Monterey Bay Aquarium Research Institute 7700 Sandholt Road, Moss Landing CA 95039			
Engineer: <Engineer> Designer: <Designer>	Title: <Title>		Project: <Project>
	Size: D	Document Number: <Doc>	Rev: <Rev>
	Date: Monday, Nov 15, 2010	Sheet 1 of 42

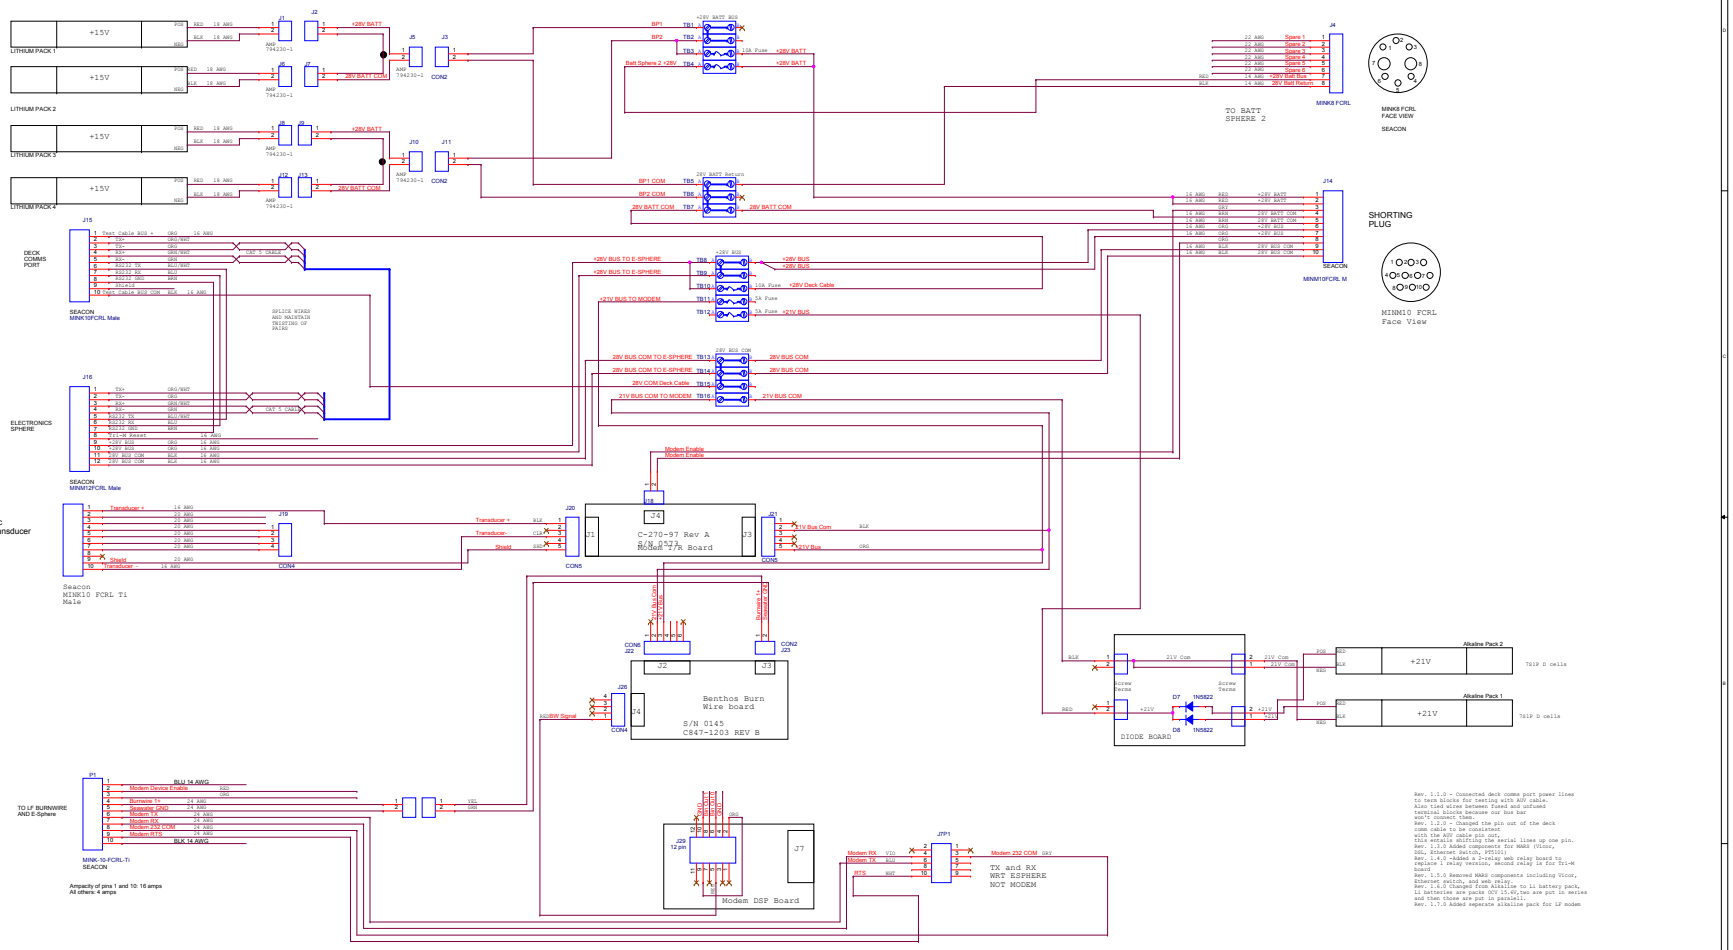
Rev. 1.1.0 - Connected deck comms port power lines to term blocks for testing with AUV cable. Also tied wires between fused and unfused terminal blocks because our bus bar is not fused yet.
Rev. 1.2.0 - Changed the pin out of the deck comm cable to be consistent with the AUV cable pin out, this entails shifting the serial lines up one pin.
Rev. 1.3.0 Added components for NARS (Vicor, DSL, Ethernet Switch, PT100 Temp sensor) and added a web relay board to replace 1 relay (relays, second relay is for Ti1-M board
Rev. 1.5.0 Removed NARS components including Vicor, Ethernet switch, and web relay.
Rev. 1.6.0 Changed alkaline pack to Li battery pack, Li batteries are packs AUV 15.0V,two are put in series and then those are put in paralell.
Rev. 1.7.0 Added seperate alkaline pack for LF modem
